January 6, 2016

**RE: Heritage Market Place  
1820 Unser Blvd NW  
Requested for 30 Day Temporary C. O. - Accepted  
Engineers Stamp Date 3/25/15 (H09D024)**

|                                      |                 |                                                                                                                          | SHEET NO<br>GR-1      |

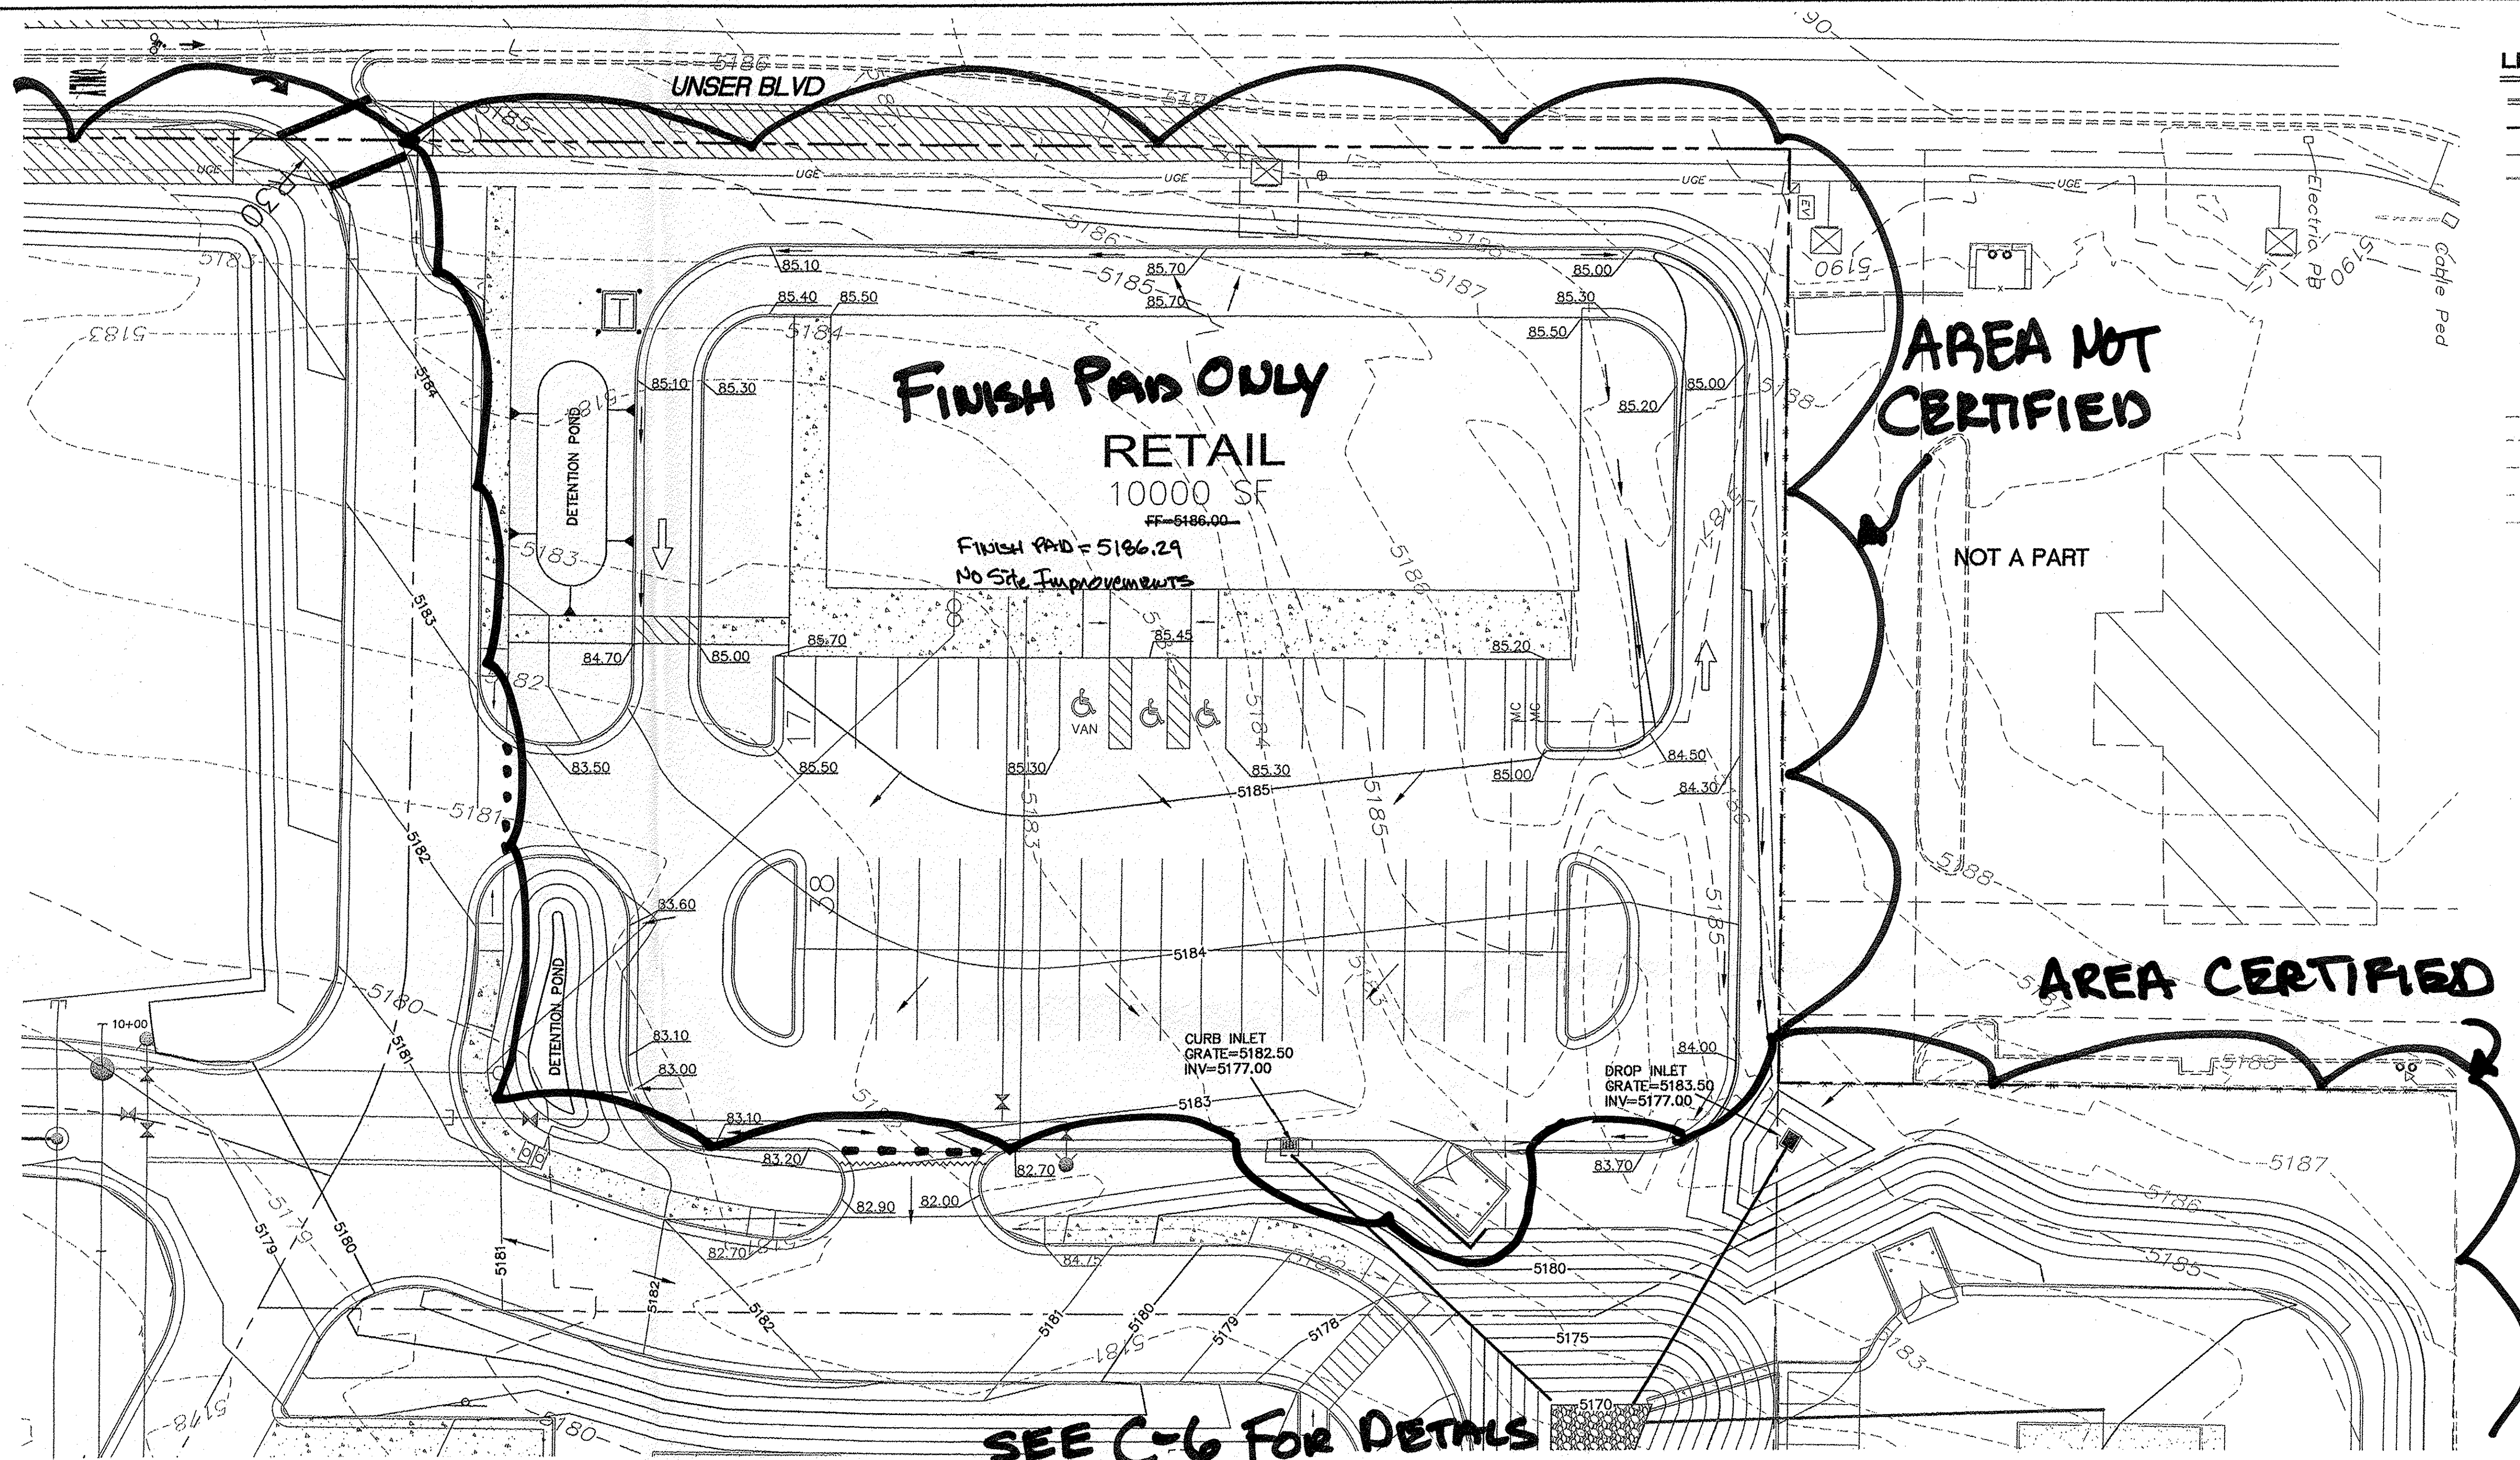
- All of the filter covers need to be removed from the drop inlets and curb inlets.

An inspection by our office will need to take place after these corrects are made.
